SDE Upgrade

WP5 ECRs

WP5 Proposal

ECR 5-2, Radio RESET routed to Micro-controller (P. Allison)

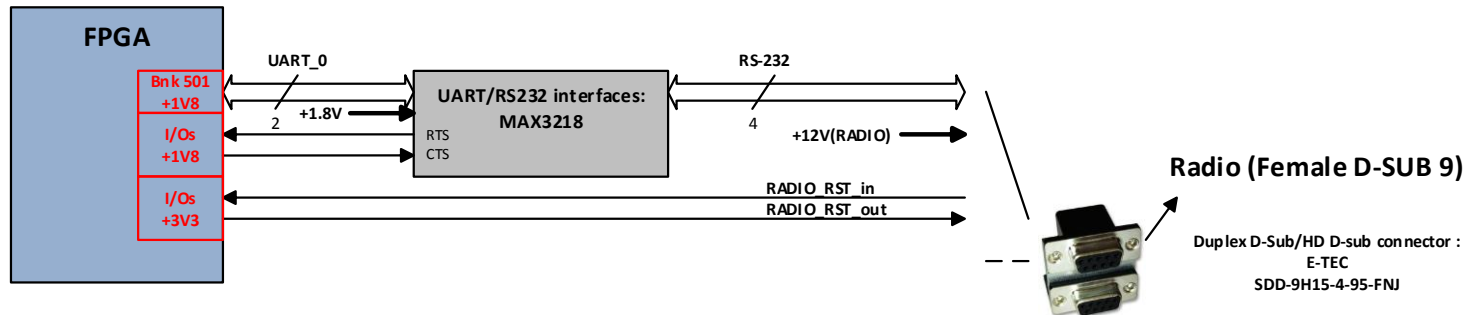
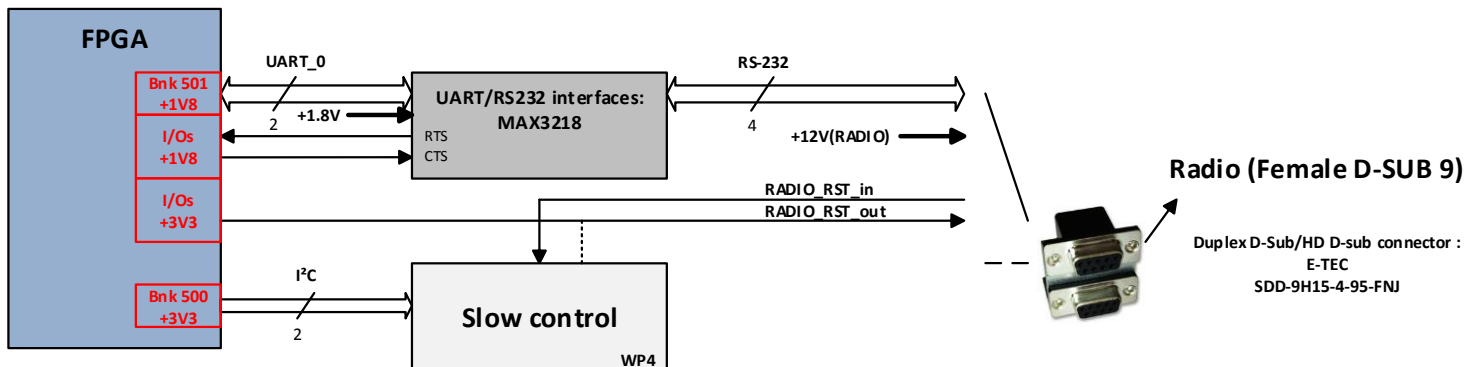
In present UUB design: RADIO_Rest_IN signal from radio is managed by FPGA

RADIO_Rest_IN signal from radio is managed by Slow-Control as the other Resets (fpga & QSPI Flash memories).

Figure 58. SNR vs. Input Frequency and Jitter

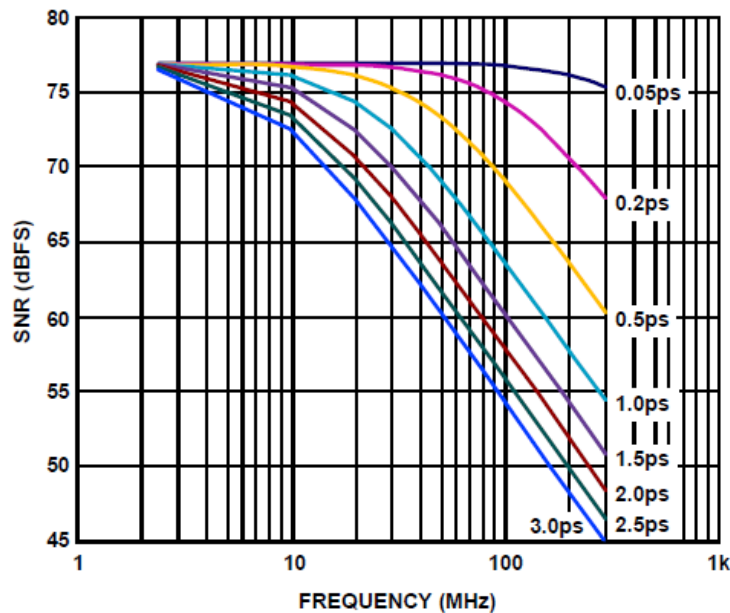
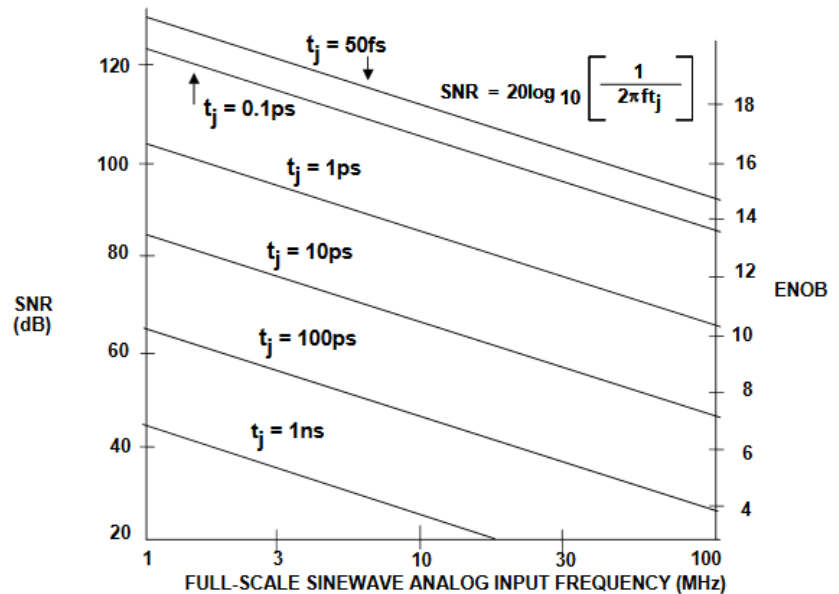
ECR 5-3, Jitter Cleaner replacement by Fanout:

WHAT DO WE NEED: Acceptable SNR (noise) MUST BE define before the choice. MORE JITTER = MORE NOISE

Lower power consumption OR Lower noise

To remove Jitter cleaner -> risk of increase of noise

ECR 5-3, Jitter Cleaner replacement by Fanout:

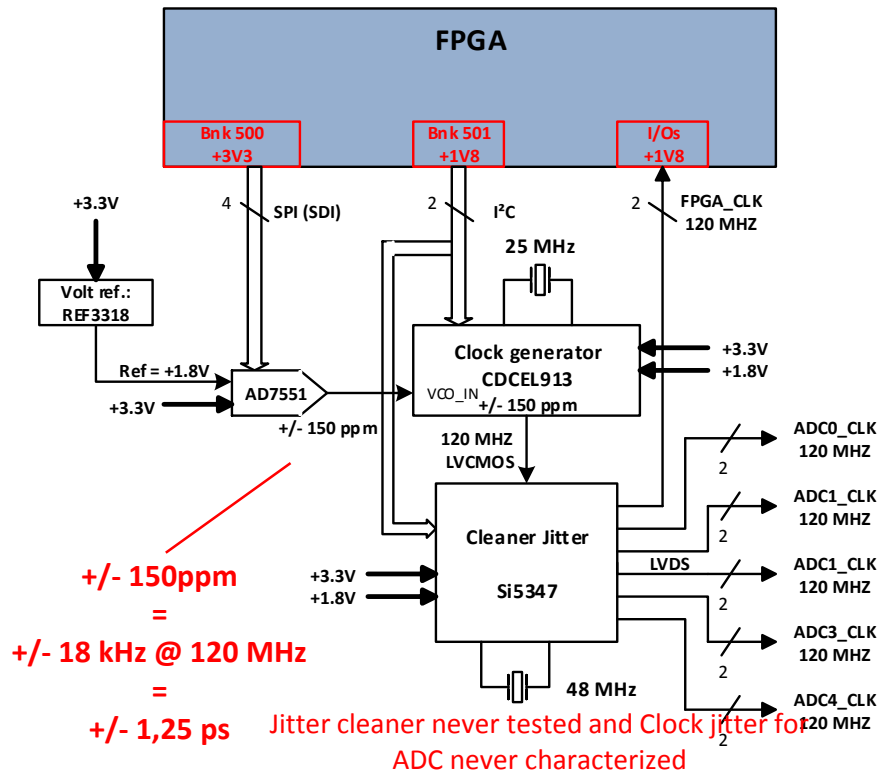
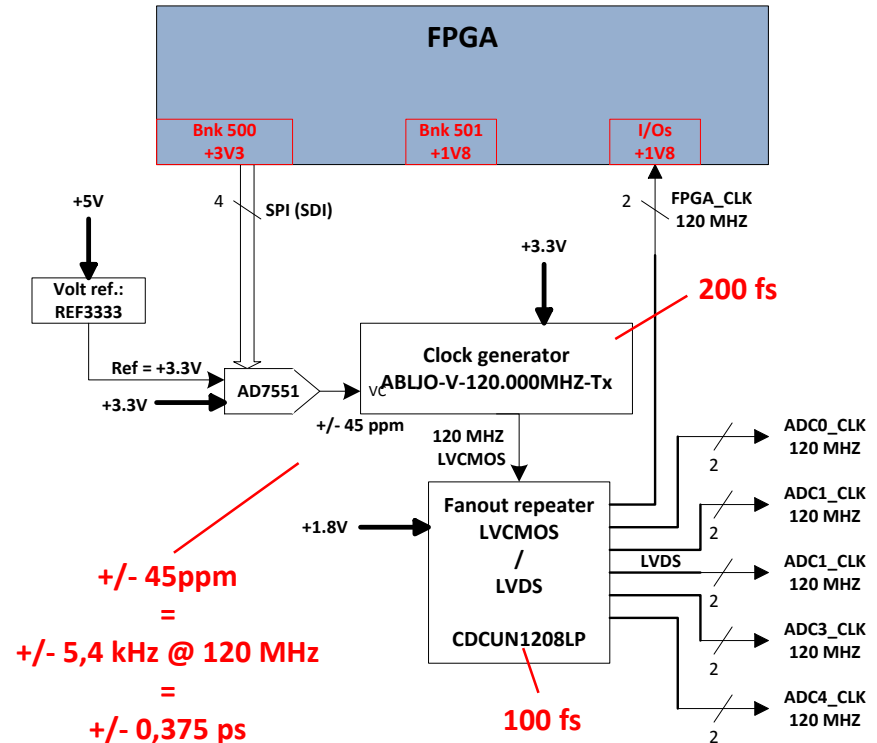
In present UUB

Compliant with ADCs 100fs specs

Clocks Jitter Estimate : 0,1 ps Max

Alternate proposal

Outside ADCs specs.

Clocks Jitter estimate : 0,3 ps RMS

ECR 5-18, Change through-hole pin connector by SMT:

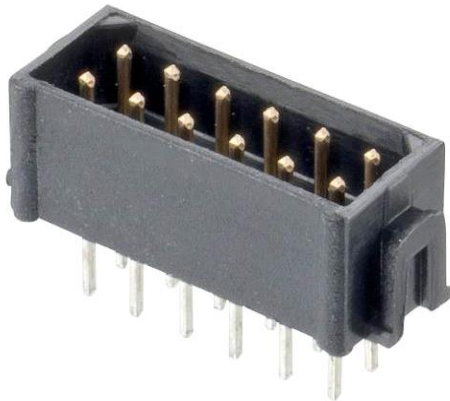
J4, J5, J7 & J9 are used for PMT and extension cable plug : could be snatched

Through-hole = Strong

SMT = fragile

Can't be production problem. Basic connector.

ECRs 14.4, 14.9 & 14.10, Resets specifications:

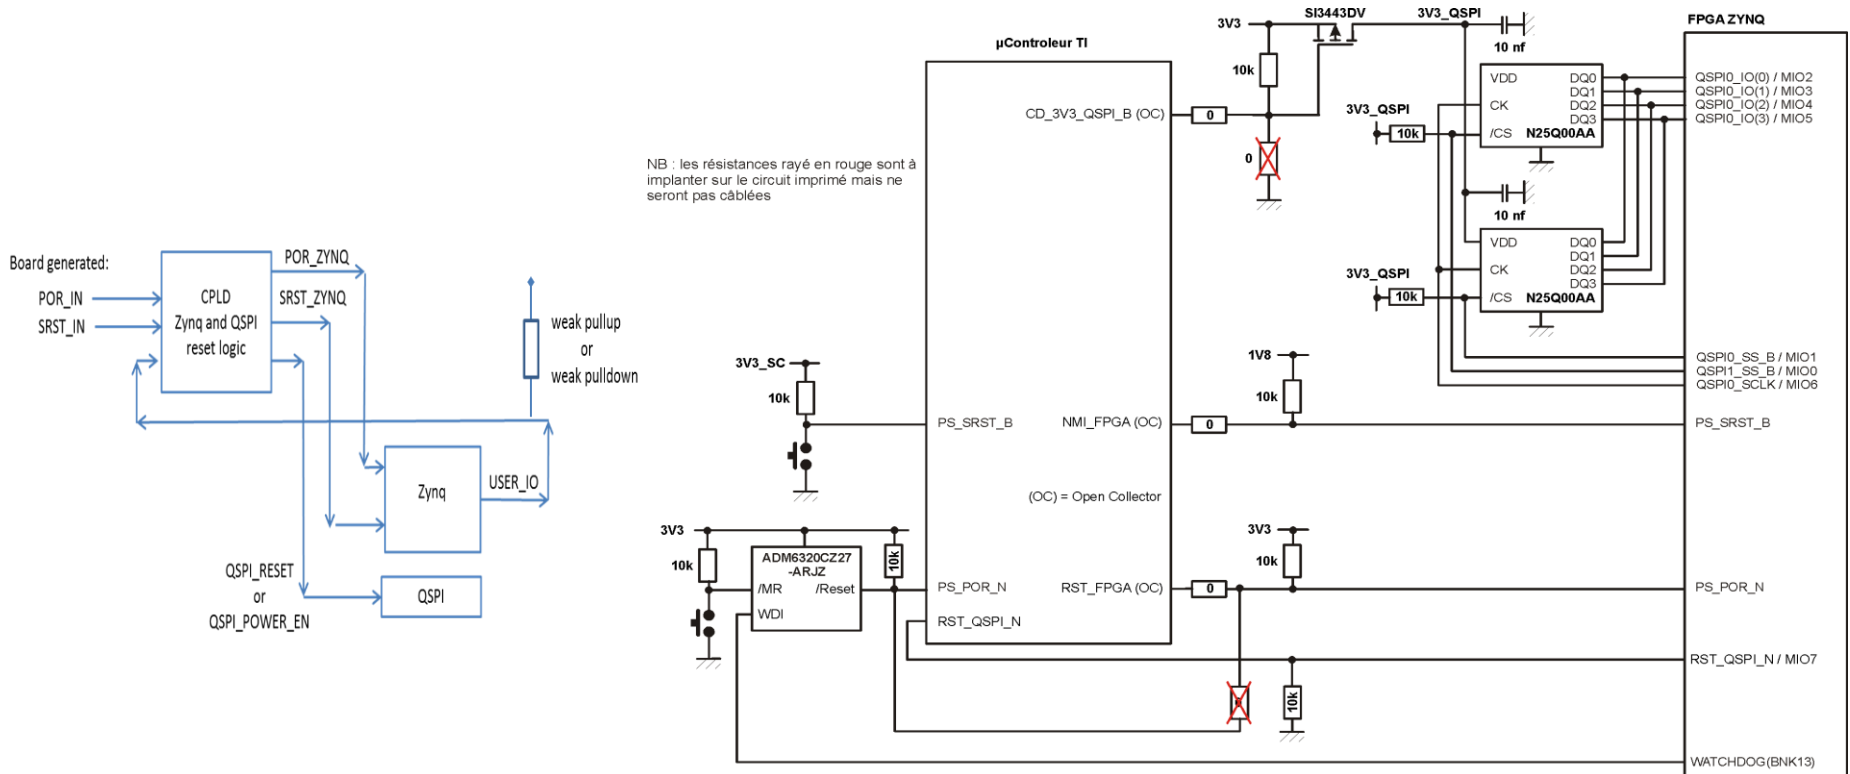
Never clearly specified:

- Watchdog: Reset UUB (FPGA+SC) or only FPGA?
- "Radio" Reset: UUB (FPGA+SC) or only FPGA?

ECR 15-1, -3,3V DC/DC to be changed :

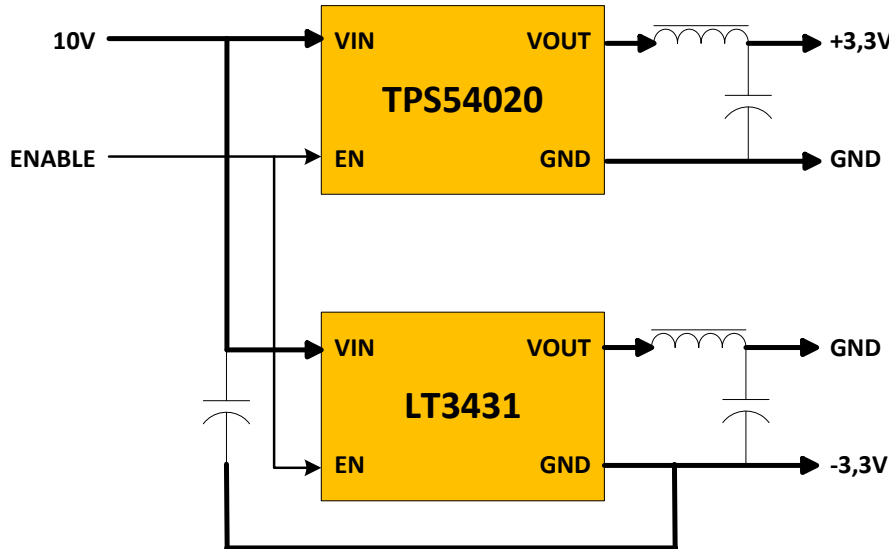
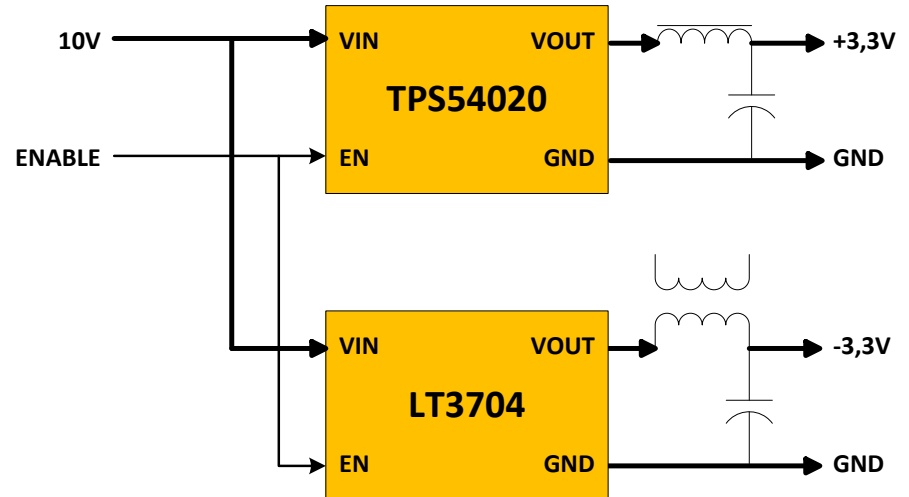
Charge pump technology
-3,3V is DC/DC voltage reference
-3,3V Enable, ERC 1-15(Feb 2016)

Not Charge pump technology: **less noisy**
"Enable" NCR suppressed

Positive voltage -> negative voltage, noisy and low efficiency

ECR 15.4 & 15.27, Optimized all DC/DC layout 1/2:

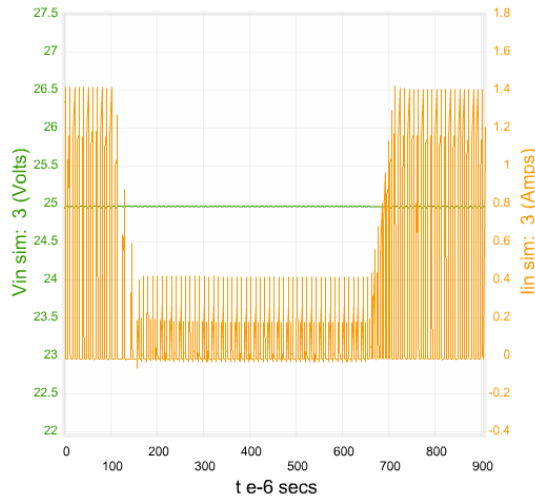
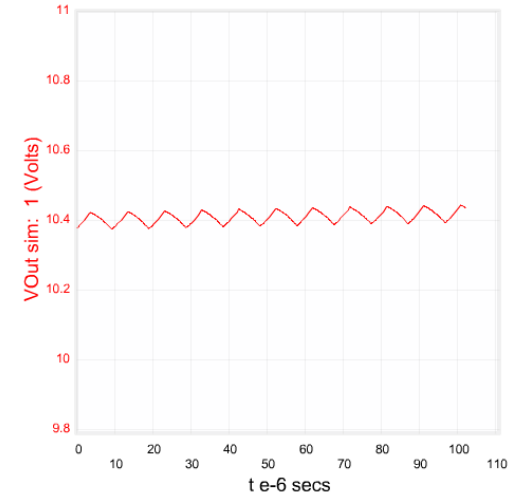
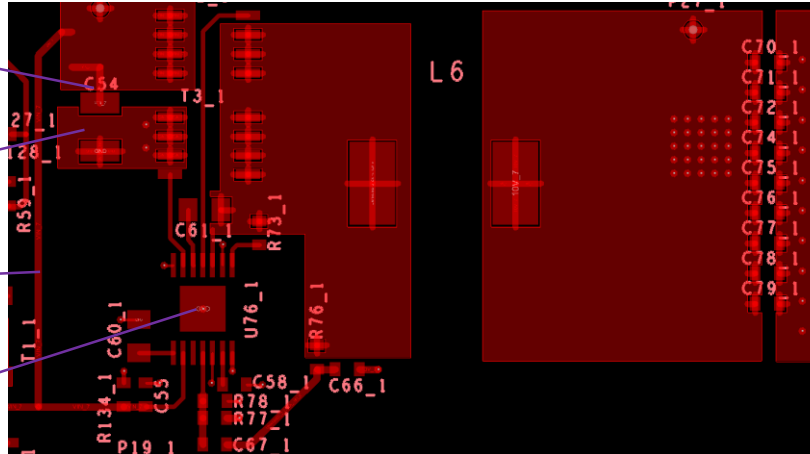
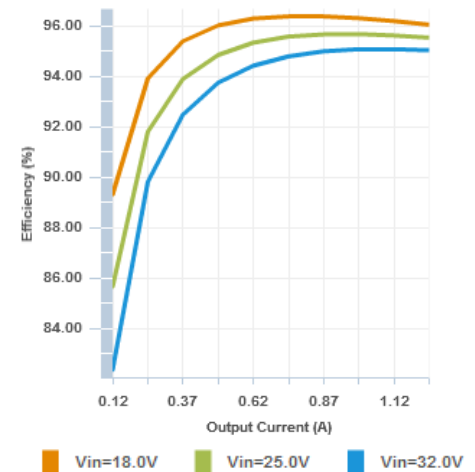
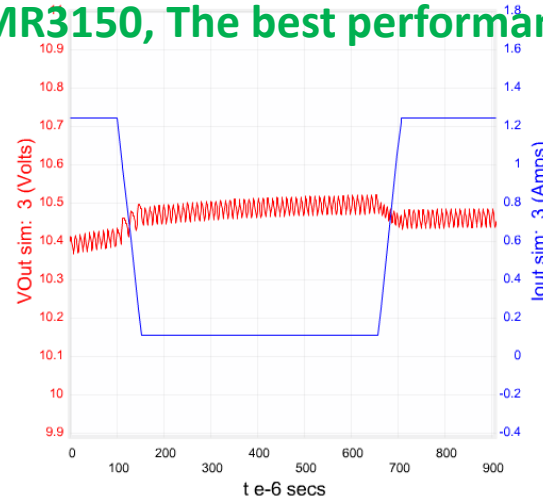
Change present 10V DC/DC LMR3150?

Design: adjust capacitor value

Layout: bad return current for input capacitor

Layout: input 24V wire too thin (R bigger = more noise)

Layout: No GND junction center on DC/DC pad.
Too few vias.

LMR3150, The best performances

ECR 15.4 & 15.27, Optimized all DC/DC layout 2/2:

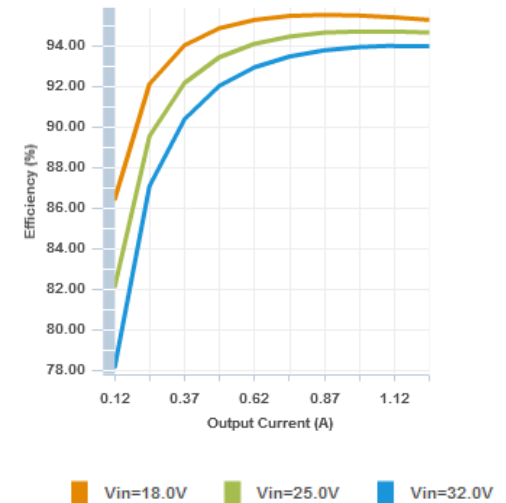
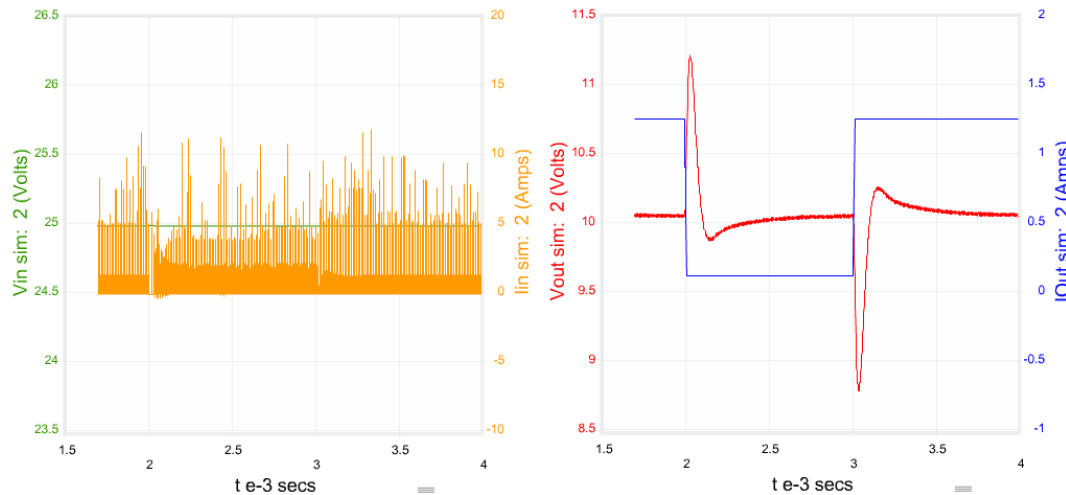
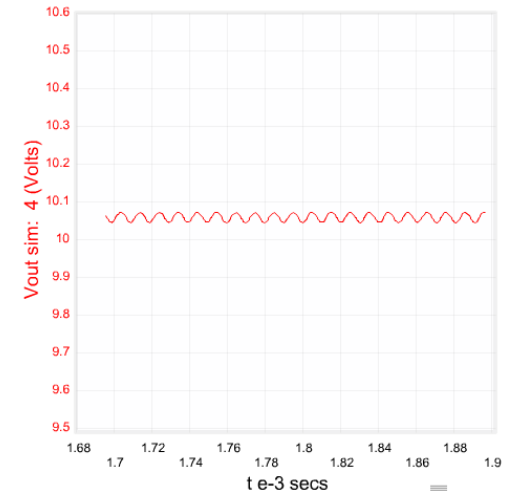
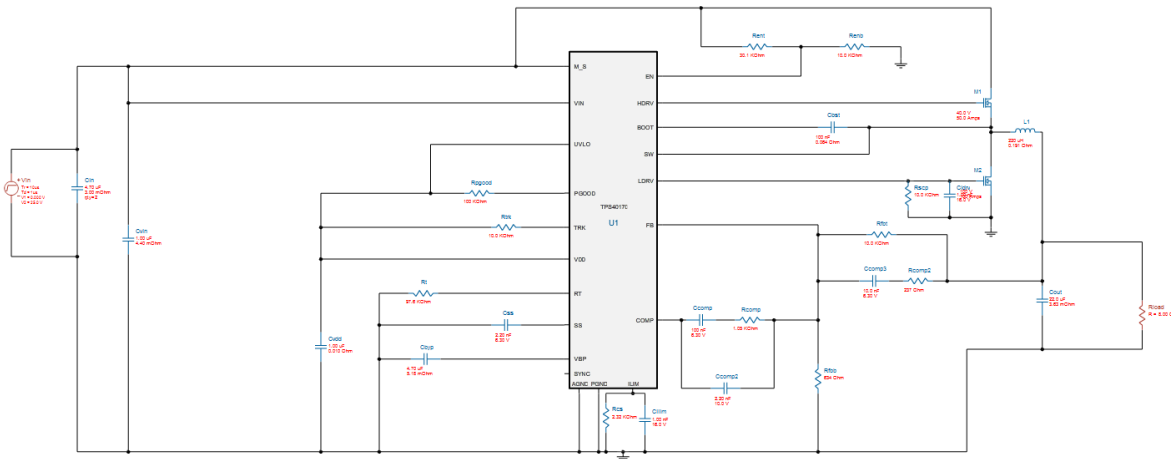
TPS40170, lower performance than LMR3150

ECR 15.8, Change Slow-control JTAG connector:

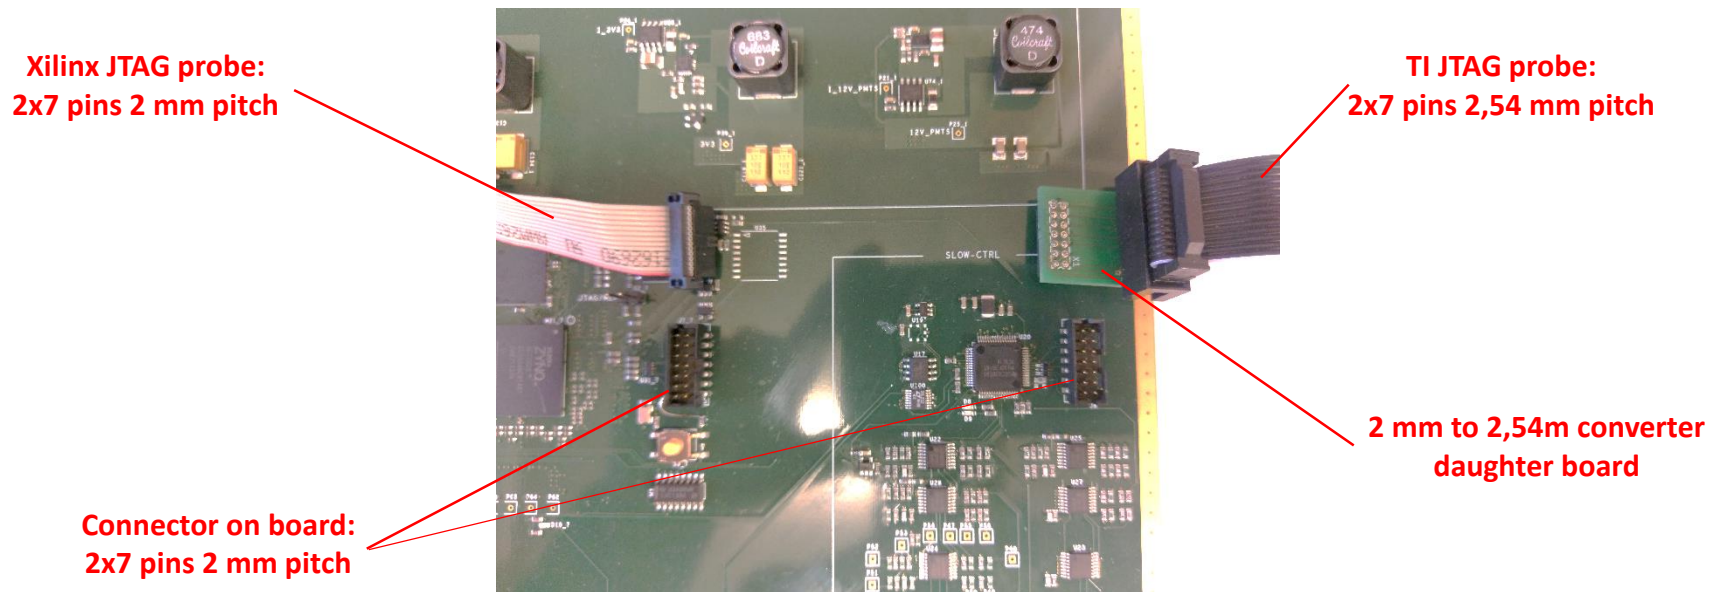
Requested at first by KIT production center, but it is a problem for maintenance. Need to be changed to 2,54 mm pitch connector.

ECR 15.11, Change Power supply connector:

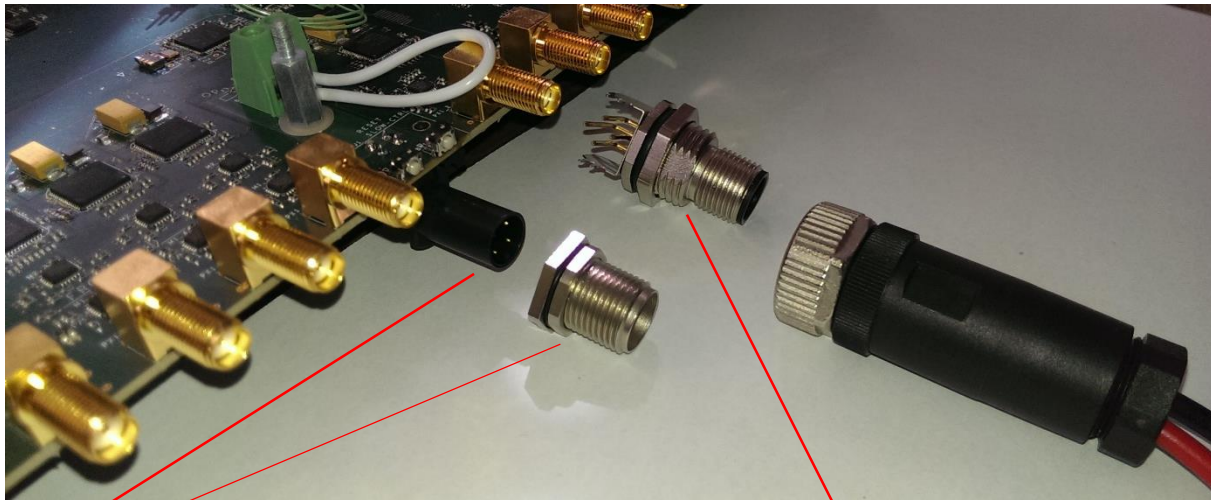
only one part and more robust. Less mechanical constraints.

Same plug.

Present version:
2 parts

next version:
1 parts
